ADDENDUM #2

VICTORIAN SQUARE INFRASTRUCTURE

BID #17/18-008 / PWP #WA-2018-010

CITY OF SPARKS
 VICTORIAN SQUARE INFRASTRUCTURE - PHASE 1
 ADDENDUM 2

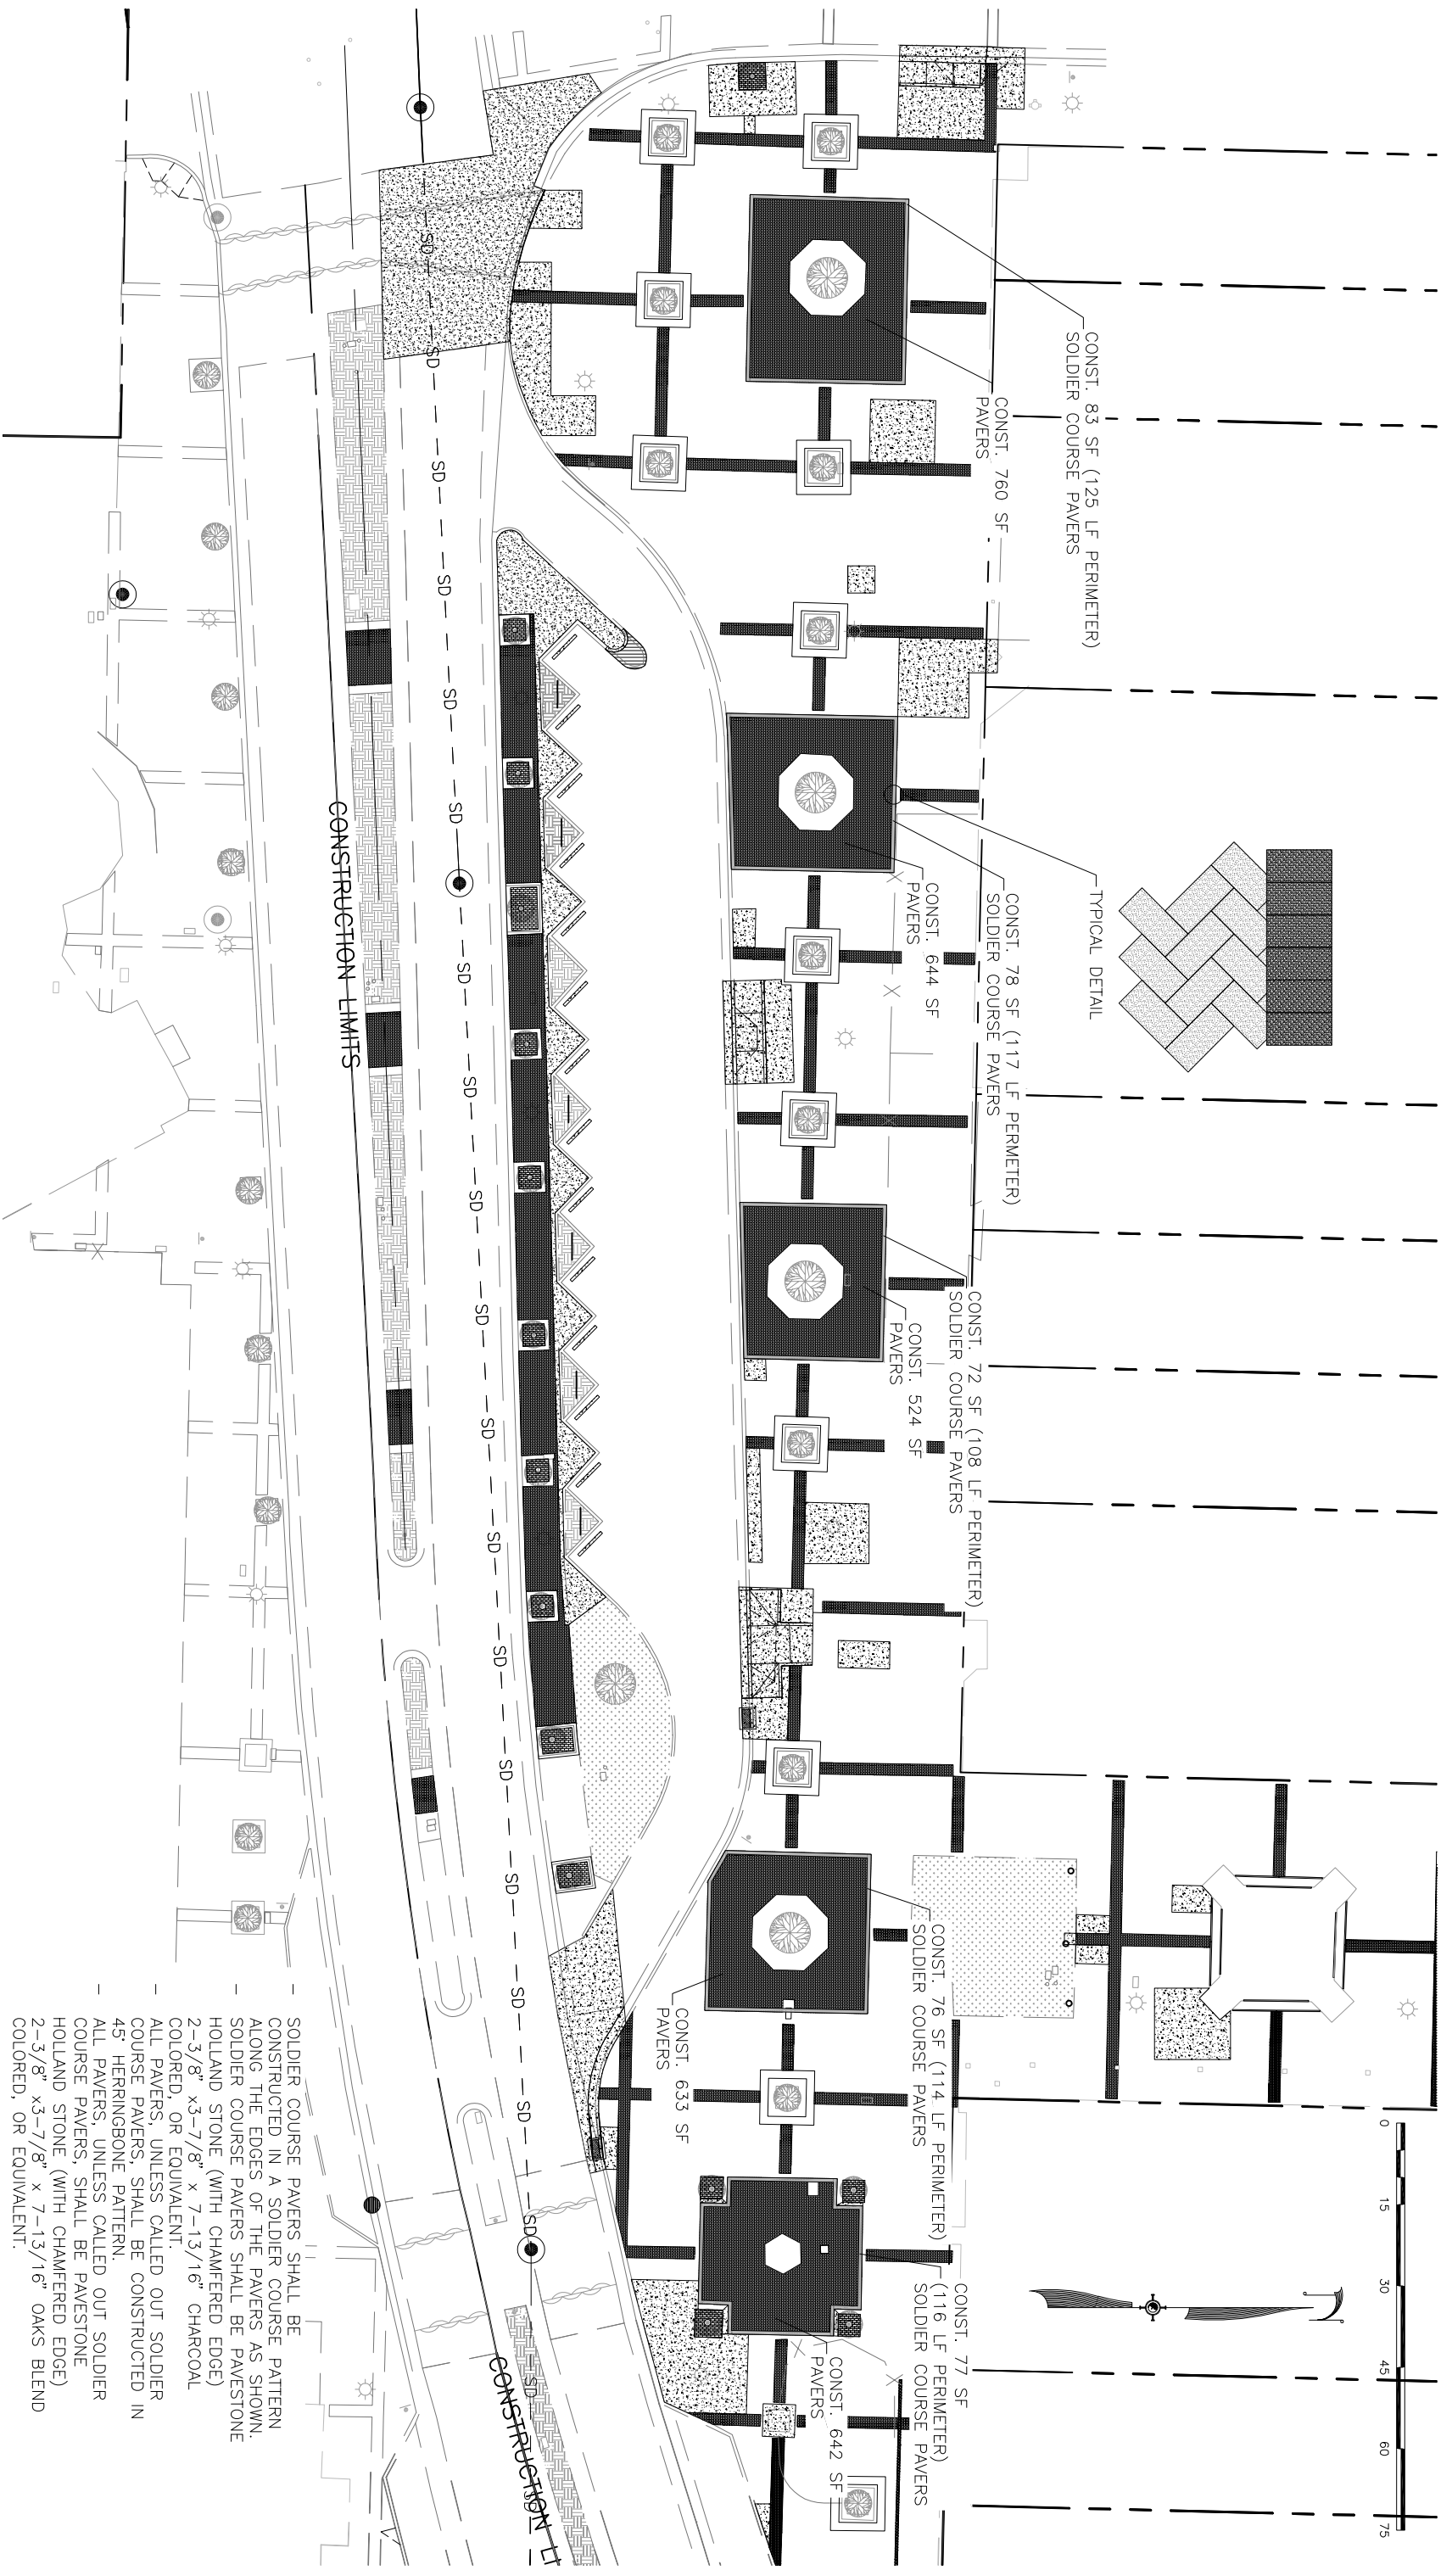
- 2) PAVER PLAN SHEET - Attached is plan sheet showing revised paver specification and locations.

SOLDIER COURSE PAVERS SHALL BE CONSTRUCTED IN A SOLDIER COURSE PATTERN ALONG THE EDGES OF THE PAVERS AS SHOWN. SOLDIER COURSE PAVERS SHALL BE PAVESTONE HOLLAND STONE (WITH CHAMFERED EDGE) 2-3/8" x3-7/8" x 7-13/16" CHARCOAL COLORED, OR EQUIVALENT.

ALL PAVERS, UNLESS CALLED OUT SOLDIER COURSE PAVERS, SHALL BE CONSTRUCTED IN 45° HERRINGBONE PATTERN.

ALL PAVERS, UNLESS CALLED OUT SOLDIER COURSE PAVERS, SHALL BE PAVESTONE HOLLAND STONE (WITH CHAMFERED EDGE) 2-3/8" x3-7/8" x 7-13/16" OAKS BLEND COLORED, OR EQUIVALENT.
